DESIGN REVIEW & PRESERVATION BOARD

LOCATION: 2230 9th Street (NW corner of 9th and W)

PROPOSAL: Rehabilitation of a two story duplex to the subject site from 2817 K Street

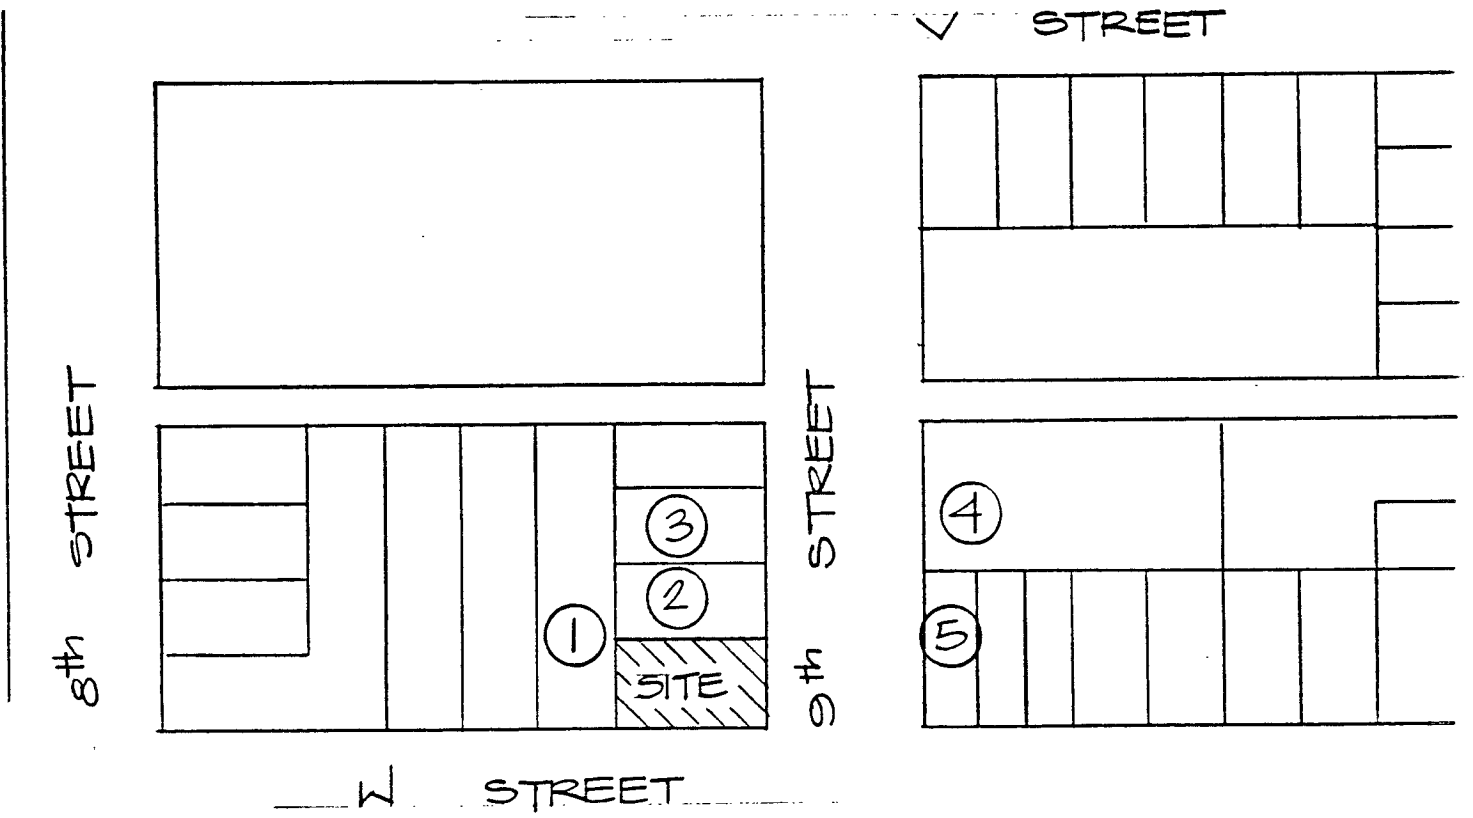
1. One parking space is required for each duplex unit. There are problems with both spaces that are indicated on the site plan. The space off of 9th Street abuts one proposed on the other house move site (DR84-117). Traffic Engineering will not issue driveway permits unless they are at least 10 feet apart. The space off of W Street has inadequate clearance for a minimum 10 foot width driveway, plus the 3 foot driveway flares, plus a 3 foot clearance to an existing street tree.

2. The front setback indicated to be 14 feet needs to be reduced in order to accommodate an adequate rear yard setback as well as the rear stairs. They may not encroach more than 4 feet into the required 15 feet rear yard. The stairs are not indicated on the site plan. On the basis of averaging the front setback of two existing dwellings on 9th Street, the minimum front yard setback permitted by ordinance is 10'-5". Staff suggests placement of the structure with the maximum front setback possible, while satisfying minimum rear yard requirements and conforming stairs. The design of the stairs and compatibility with building design and location of windows and doors should be subject to staff's review and approval.

3. Plans imply the location of a covered patio within the 15 required rear yard setback. Such location is contrary to the Zoning Ordinance and would require a Variance. The design of a patio cover if a Variance is granted, should be subject to staff review and approval.

1. The Special Permit for a second unit, must be approved by the Planning Commission, or the structure shall be converted to single family use.
2. The applicant shall resolve the issue of required parking.

- a. Two parking spaces shall be provided; or
 - b. The applicant must be granted a variance to reduce or waive the parking requirement; and
 - c. No street trees may be removed without the approval of the City Arborist.

3. All setbacks shall be in compliance with the Zoning Ordinance unless reduced by Variance approval of the Planning Commission. Maximum possible front setback shall be provided, subject to staff review.

4. The rear stairs shall be in conformance with City codes. They shall be compatible with the building's design and shall not conflict with windows or doors, subject to staff review and approval.

5. Any covered patio shall conform to minimum building setbacks unless authorized through variance approvals. If a variance is approved, patio cover to be reviewed and approved by staff.
